**SUPPLEMENTARY INFORMATION**

**Planning Committee**

17/02534/OUT – Land North Of Bicester Avenue Garden Centre, Oxford Road, Bicester

# UPDATE TO OXFORDSHIRE COUNTY COUNCIL'S RESPONSE TO CONSULTATION ON THE FOLLOWING DEVELOPMENT PROPOSAL

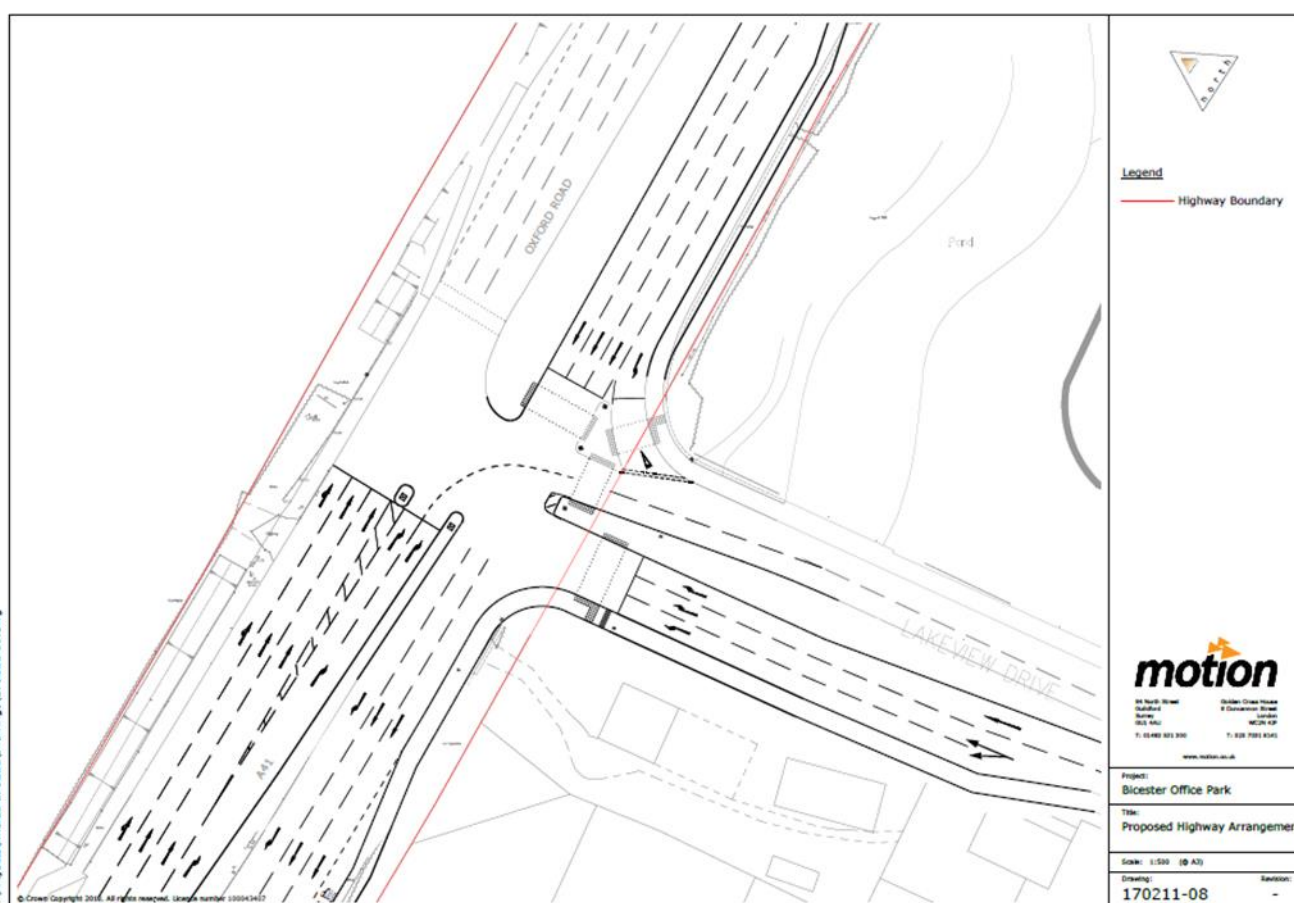
- Paragraph 8.9 states that third party advice has been sought on the appropriate threshold Degree of Saturation above which signalised junctions stop being considered to operate within capacity. It is the County Council's firm belief that in the transport industry it is widely accepted that where the Degree of Saturation (DoS) of a link in a LinSig model is shown to operate in excess of 90% DoS, that link is operating over capacity. The following extract from the TfL document "Traffic modelling Guidelines" supports this comment:

It is useful to be aware of the relationship between traffic delay and DoS in order to best optimise junction performance during proposal development. The relationship illustrated within Figure 8 strengthens the considerations outlined in Part A, which highlight the role stable network performance can play in maintaining journey time reliability. Engineers should be mindful that delay begins to increase exponentially above approximately 85% DoS. At junctions operating close to zero Practical Reserve Capacity (PRC), corresponding to approximately 90% DoS, small reductions in capacity can result in a significant increase in delay. For this reason a DoS of 90% represents an upper limit of practical capacity for signalised junctions. Unsignalised junctions typically have a lower practical capacity limit, with DoS in the range 80-85%. Junction capacity relationships are important when designing schemes in order to ensure that new proposals perform capably within the existing network.

Notwithstanding this, the LinSig modelling results for queuing show that the mitigation scheme is not adequate in terms of the resultant queueing. In other words, OCC is not objecting on the basis of an obscure technicality, but on predicted queueing, as paragraph 8.10 goes on to explain.
